SAN ONOFRE NUCLEAR GENERATING STATION, UNIT NO. 1

AMENDMENT TO FACILITY OPERATING LICENSE

Amendment No. 155
License No. DPR-13

PERMANENTLY DEFUELED TECHNICAL SPECIFICATIONS

FIGURE D5.1-1
EXCLUSION AREA

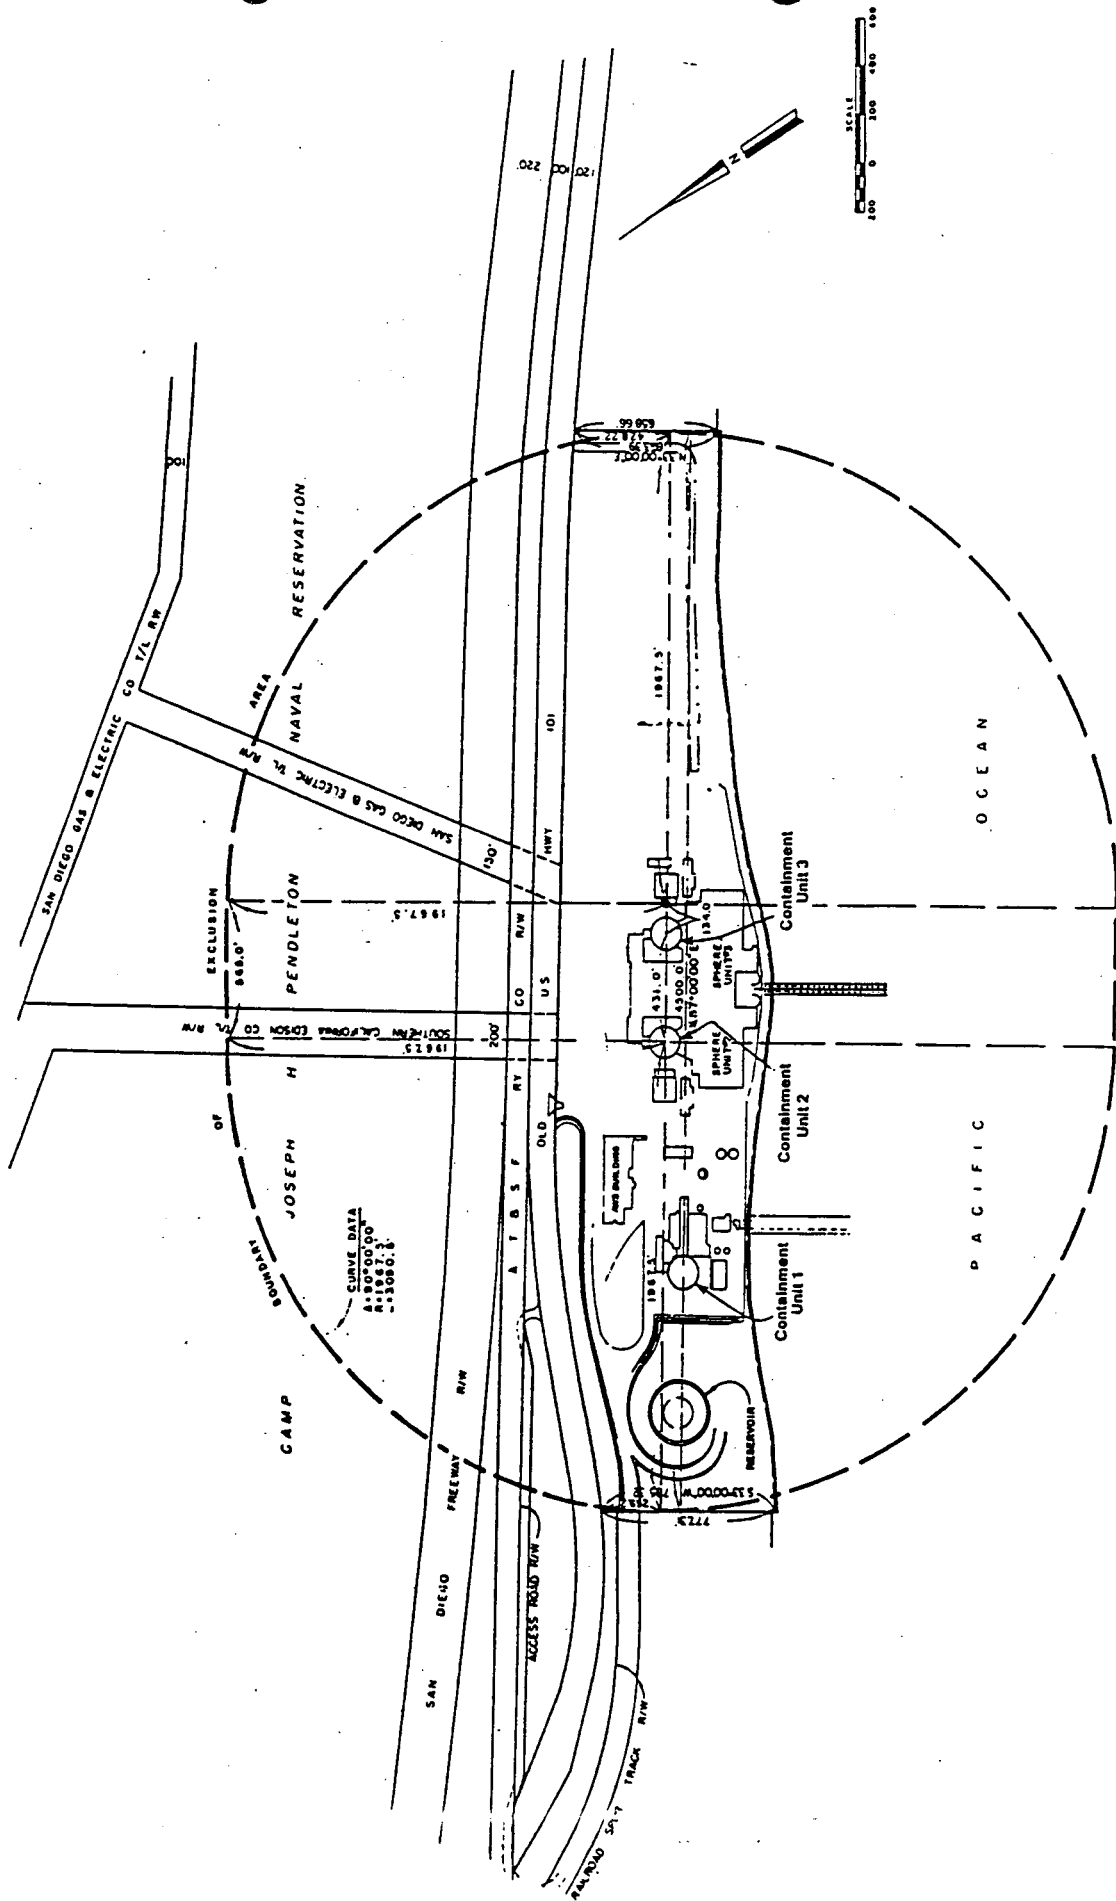
The licensee proposes to make the following changes for Section D5, Design Features, of the proposed PDTs; (1) Section D5.1, Site Description, will be revised to reflect the presence of Units 2 and 3 at the San Onofre Nuclear Station site, (2) Section 5.1, Basis, will be omitted, because the information included in that section would be redundant to the proposed information in Section D5.1, (3) Sections 5.2 and 5.3 would be omitted from the PDTs, since

The minimum distance to the boundary of the exclusion area, as defined in 10 CFR 100.3, shall be 283.5 meters from the outer edge of the Unit 1 containment sphere. For the purpose of dose assessment, a slightly reduced distance of 282 meters defined by the discontinuous line in Figure D5.1-1 is assumed.
